# UNITED STATES PATENT AND TRADEMARK OFFICE

10/826,432

<b>Office Action Summary</b>	<b>Application No.</b> 10/826,432	<b>Applicant(s)</b> KASTRUP ET AL.	
	<b>Examiner</b> ANDREW NGUYEN	<b>Art Unit</b> 3746

### **DETAILED ACTION**

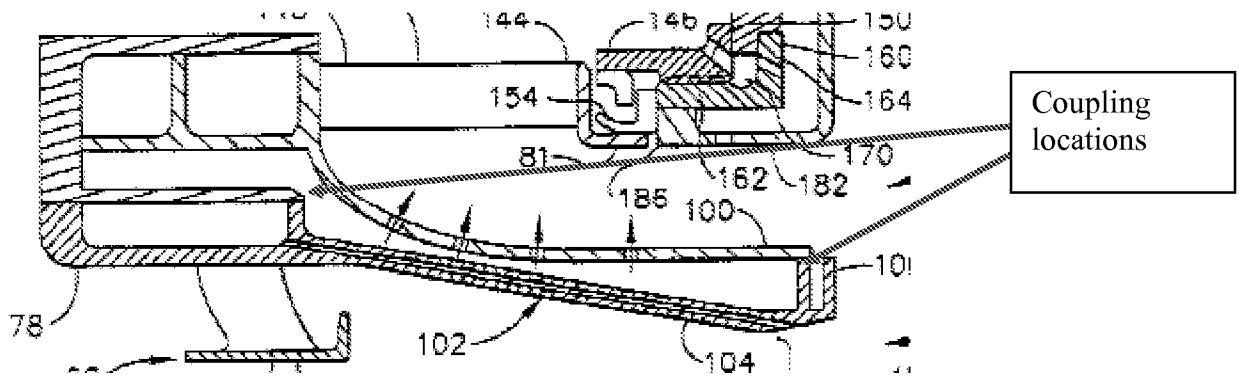
With regard to Applicant's assertion that Bibler fails to teach "a swirler coupled to the venturi to facilitate preventing a flow of fuel ... at upstream and downstream portions", Examiner

asserts that the swirler and venturi are coupled such that there is no passage for fuel to flow at the upstream and downstream portions. See the drawing below.
